ENTERGY OPERATIONS, INC.

ARKANSAS NUCLEAR ONE, UNIT ONE

Subject: Arkansas Nuclear One - Unit 1
Docket No. 50-313
License No. DPR-51
Proposed Technical Specification Change Revising The Pressurizer Code Safety
As-Found Setpoint Tolerance

DESCRIPTION OF PROPOSED CHANGES

FIG. NO.
 14-8

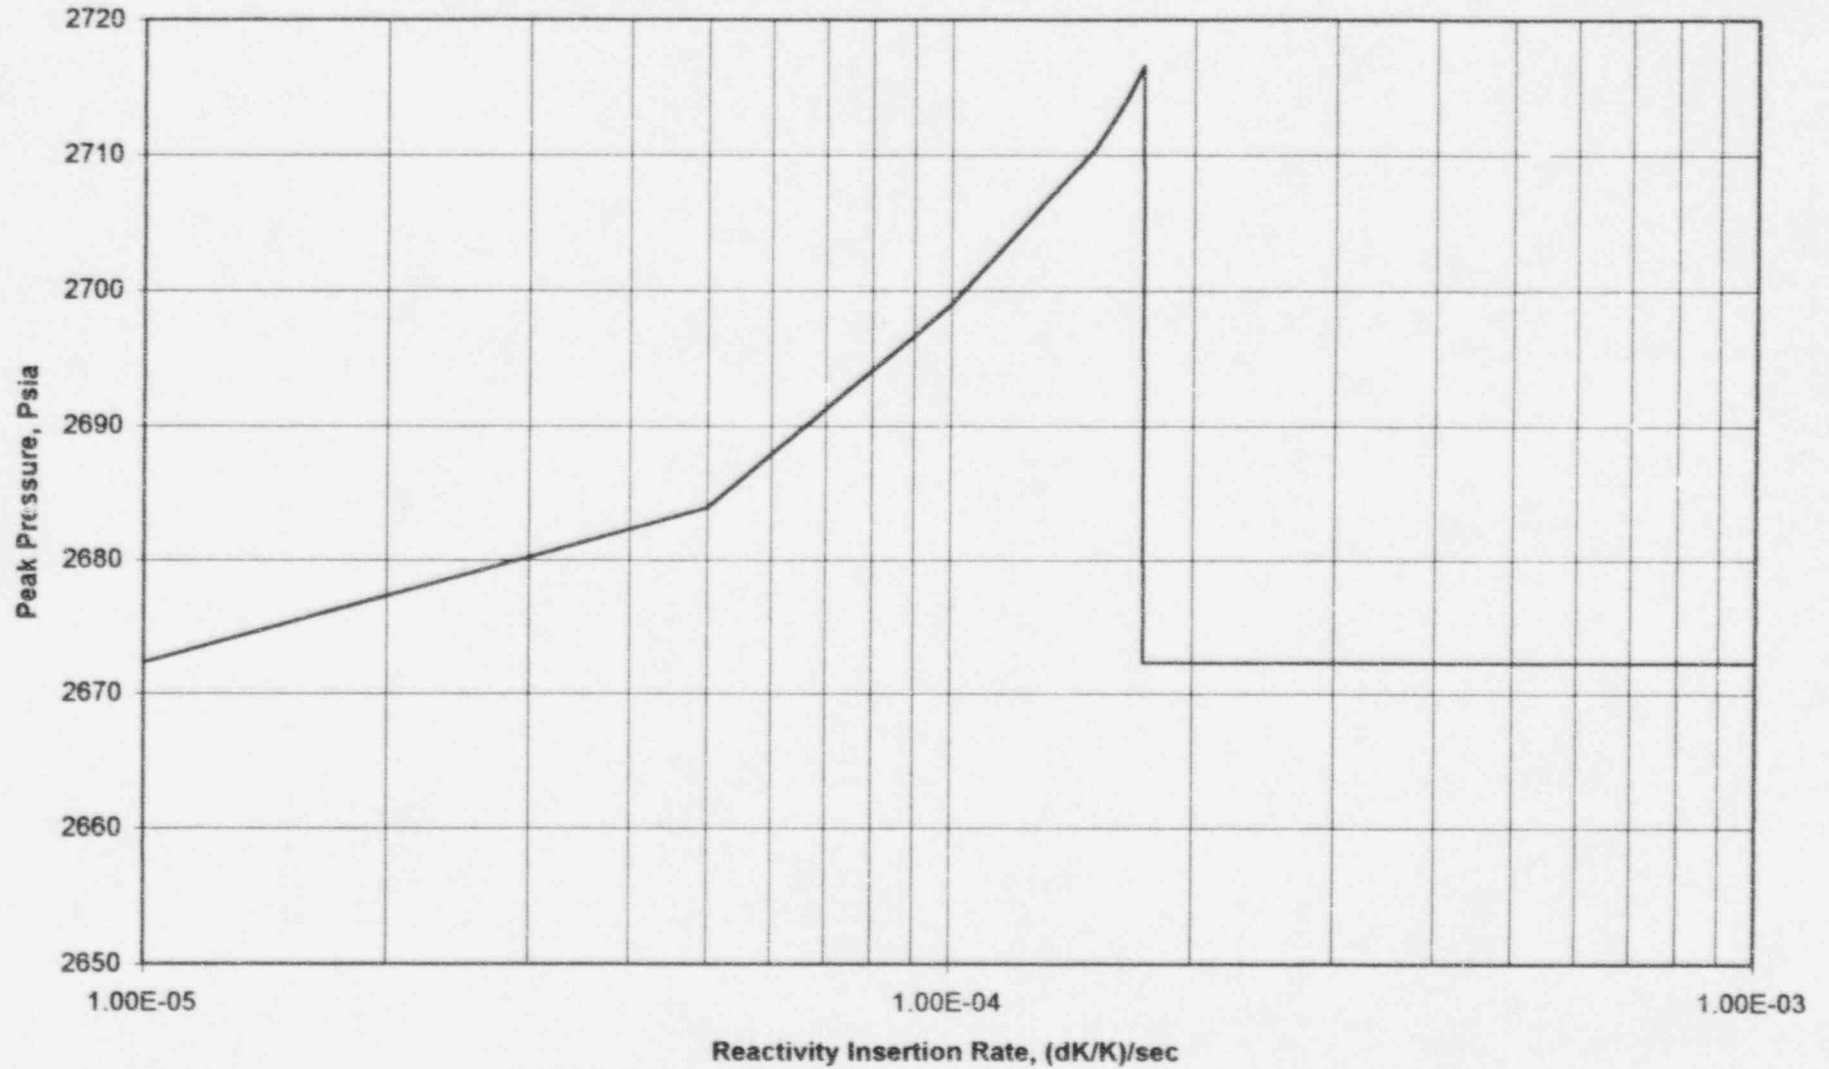
Figure 14-8 shows the effect of varying the reactivity addition rate on peak pressure.
